1	Encoding Guide Request for an amendment (e.g. new picture, new coding instruction or new real world entity, which is encoded by already existing object classes, attributes and attribute values, but requires no alteration of existing elements)				
		cture, illustration or an already existin fects the Feature Catalogue	ng text)		
2	Sections A and B	Sections C to U	Section V to Z and Annexes AA and AB		
	This is a request ☐ referring to lit. C of scetion B ☐ for a new lit.	This is a request referring to page(s) (e.g.: C.1.5) of the Encoding Guide	This is a request referring to section		
	(Continue with 4)	(Continue with 3) for a new page in section (e.g.: E.1) of the Encoding Guide (Add the proposal on page 2 and continue with 6 on this page)	(Continue with 4)		
3	□ Definition □ Picture: □ real world □ paper chart □ IENC □ Coding instruction lit. □ Object coding of object class □ Illustration

Memo

Topic: Unsurveyed areas in IENCs

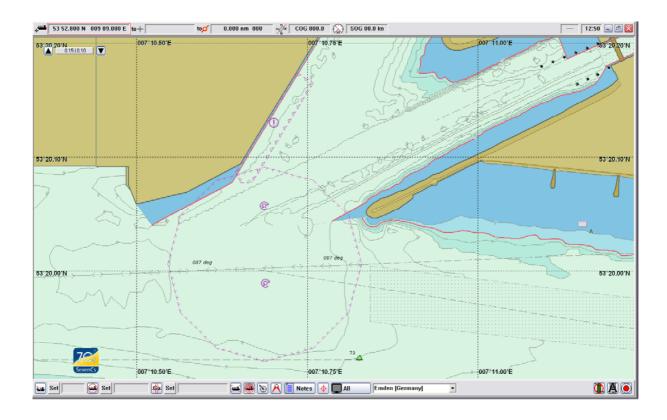
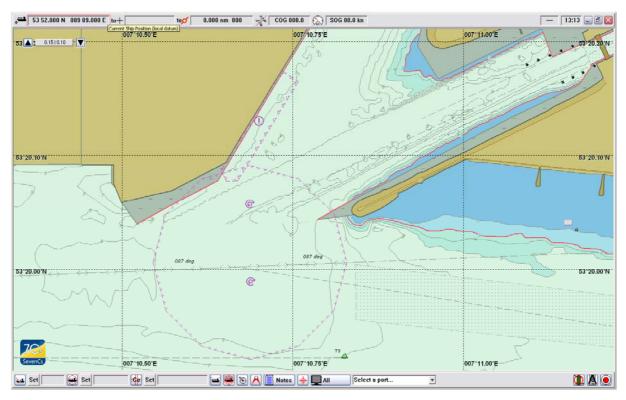
S-57 knows the feature UNSARE to encode an area for which no bathymetric survey information is available. UNSARE has its own symbolization that clearly distinguishes UNSARE from DEPARE on the display. The present encoding instruction in the Encoding Guide, however, is to use a DEPARE or depare feature with DRVAL1 = ["0"] and DRVAL2 = ["unknown" or [x.x] (meters), e.g. 2.7]. I was unsuccessful in trying to recollect what reasons we had in the past not to use UNSARE.

There are however reasons to reopen the discussion of how to handle unsurveyed areas.

The present solution using DEPARE or depare gives no immediate visual cues to distinguish between:

- an area that has been surveyed but has insufficient water depth or
- an area that has not been surveyed and may have sufficient water depth.

The examples seem to be sufficient reason to propose an amendment of the IENC Encoding Guide to encode unsurveyed areas with UNSARE.

Reported depth

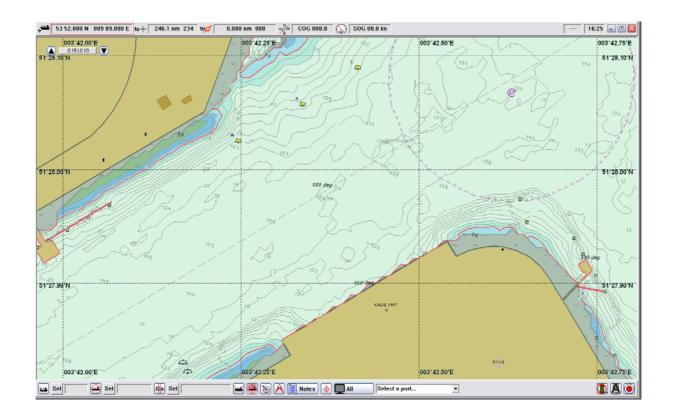
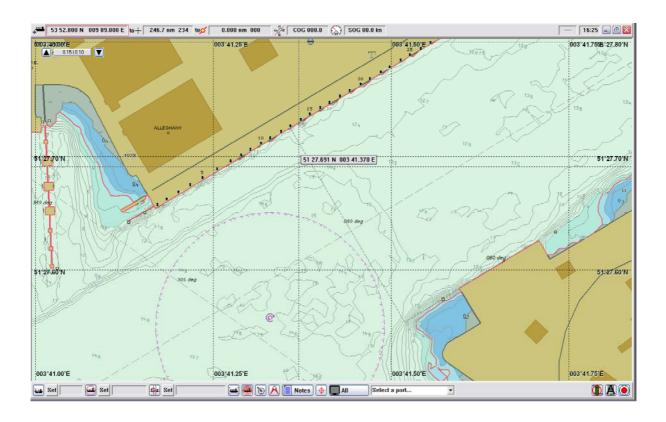
The exception to the proposal of the previous paragraph are cases where parts of the navigable water area are not surveyed but may be deep enough for navigation, like in sidearms or private marinas. In this case I would propose to keep the present encoding instruction DEPARE with QUASOU = 2 (depth unknown) or 8 (value reported (not surveyed)) in order to show that ships may navigate in these areas as well.
